ZONING STAFF REPORT

Date: November 12, 2021
Case No.: 2021-2355-ZC
Posted: November 26, 2021

PETITIONER: George Kurz
OWNER: Honeybee Holdings, LLC
REQUESTED CHANGE: From A-4A Single-Family Residential District TO A-4A Single-Family Residential District and PUD Planned Unit Development
LOCATION: Parcel located on the east and west sides of Honeybee Road, north of US Highway 190; Slidell; S35, T8S, R13E; Ward 9, District 11
SIZE: 275.33 acres

CONCEPTUAL PLAN FOR REZONING HONEYBEE SUBDIVISION A PLANNED UNIT DEVELOPMENT SECTION 35, TOWNSHIP 8 SOUTH - RANGE 13 EAST GREENSBURG LAND DISTRICT ST. TAMMANY PARISH, LOUISIANA

Project information: DRAWN NUL, CHECKED EHS, ISSUED DATE 03-19-2021, ISSUED FOR REZONING, PROJECT NO. 20-889, FILE 20-889 PUD-1, SHEET PUD-1.

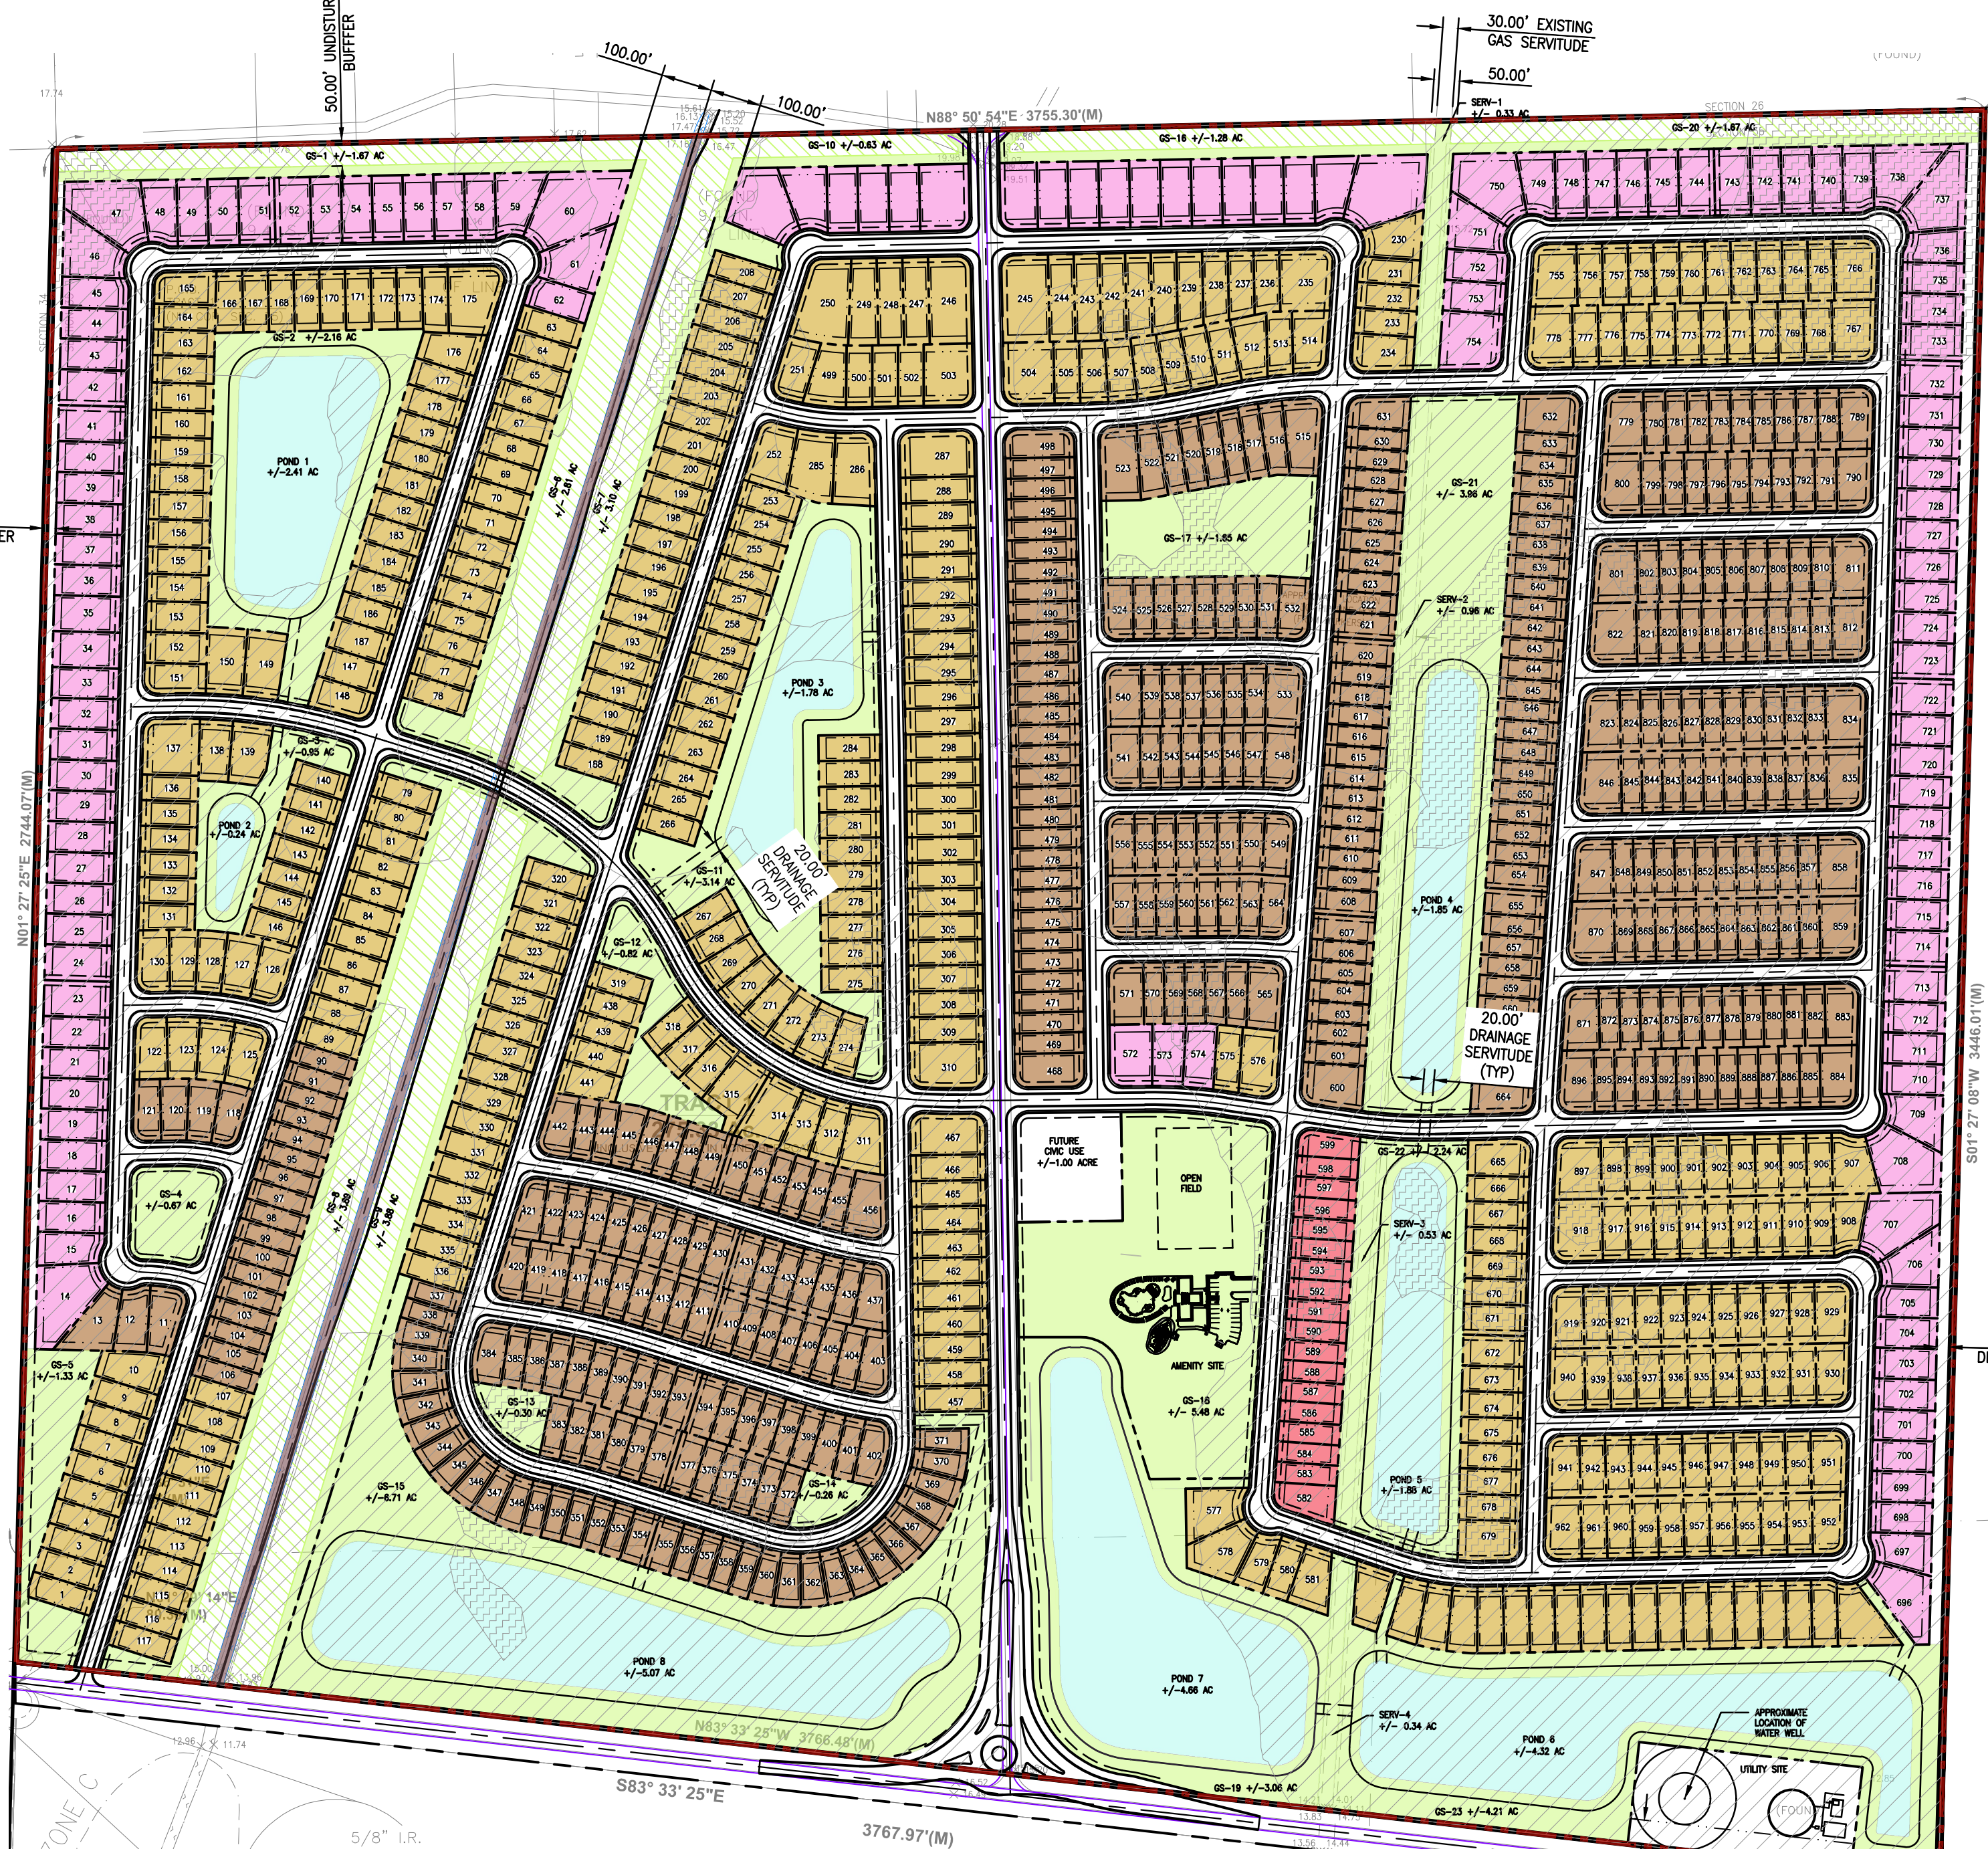
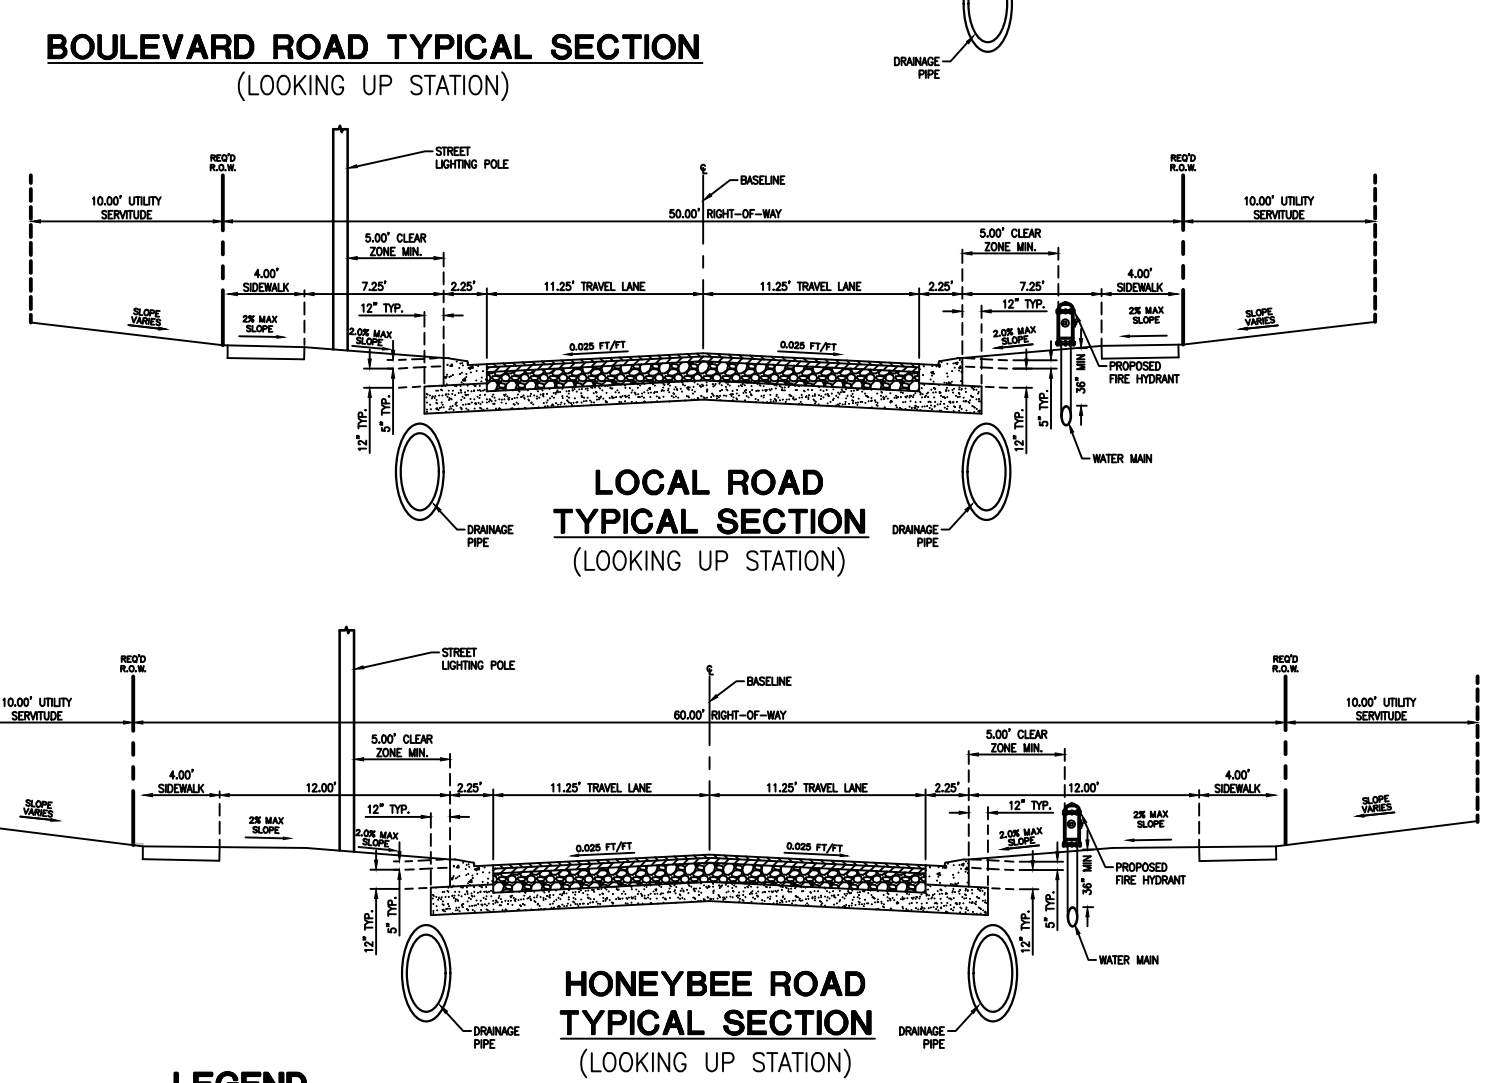
Per the UDC, Section 130-1674(a)(8), a minimum of 25% of open space is required for all PUD subdivisions. The petitioned PUD consists of 275.33 acres, requiring 68.83 acres of open space. The Honeybee PUD plan shows a total of 69.08 acres of greenspace.

Staff has concerns that a large majority of the greenspace provided is comprised of easements, servitudes, and buffers, and therefore ~~does not meet the intent of the PUD requirements~~ **is not of a higher quality than would be possible without the PUD.** (see Table 4). ~~While not opposed to the addition of several acres of pocket parks situated throughout the PUD, staff would like to see that more amenities are added to these parks to ensure the greenspace that is provided is functional and beneficial to the residents. Currently, it appears as though the Honeybee PUD is providing three playground sets and an “open field” to accommodate 962 proposed home sites.~~ **As per Table 4, if the applicant eliminated Bayou Paquet, the gas servitude, “space around the lakes”, and buffers from the total amount of greenspace provided, the PUD plan would be providing 36.59 acres, which is merely 53% of the greenspace required.**

*This illustration is not meant to show that the proposed amenities would not meet the subdivision ordinance, but rather to note that 47% of the greenspace provided on the PUD plan is comprised of easements, servitudes, and buffers which would not be permitted if the property were to be developed without the PUD overlay and is therefore not of a higher quality.

- As shown in Table 1, the Honeybee PUD is providing eighteen-35 ft. wide lots for the construction of Cottage Style homes. This means that 944 of the 968 lots fluctuate by a width of 10 feet. Staff has determined that these lot sizes ~~and~~ do not provide the diversification and variation of residential uses encouraged by the Planned Unit Development.

- The applicant has stated that the proposed Honeybee PUD will provide a swimming pool, a clubhouse, an open sports field, three playgrounds, and sidewalks throughout the neighborhood. The PUD ordinance requires active and passive uses but does not list how much of each is required. Staff questions whether the amenities listed provide enough public benefit to negate the required lot size requirements that a typical subdivision would need to follow. ~~Almost 63% of the greenspace provided is comprised of required area around the ponds, greenspace buffers, and servitudes. Considering the high density of the proposed subdivision, additional active areas and amenities~~

- Although not required, the Department of Planning and Development strongly encourages buffers along the exterior property lines of proposed subdivisions. The applicant has provided a 50 ft. “landscape buffer” along Highway 190 **and** a 50 ft. “undisturbed buffer” to the north **which are included in the greenspace calculations.** ~~as well as a two 25 ft. “disturbed buffers” to the east and west.~~ While staff welcomes the use of greenspace to screen the residential development from existing land uses, staff has determined that these buffers should not ~~help to make up the majority of~~ **contribute any portion of required** green space amenities for the residents.

- ~~Due to the proposed high density of this PUD, the applicant should ensure every home site has access to a substantial greenspace amenity. In addition, the applicant should ensure parking is provided at all three amenity sites to ensure that every home has reasonable access.~~
- **The applicant has provided a “PUD Walking Exhibit” which shows a ½ mile radius circle centered on each park location. This plan illustrates that every lot in the development is within ½ mile from a playground. In addition, the developer has agreed to add parking at all playground locations to ensure that every home has reasonable access.**
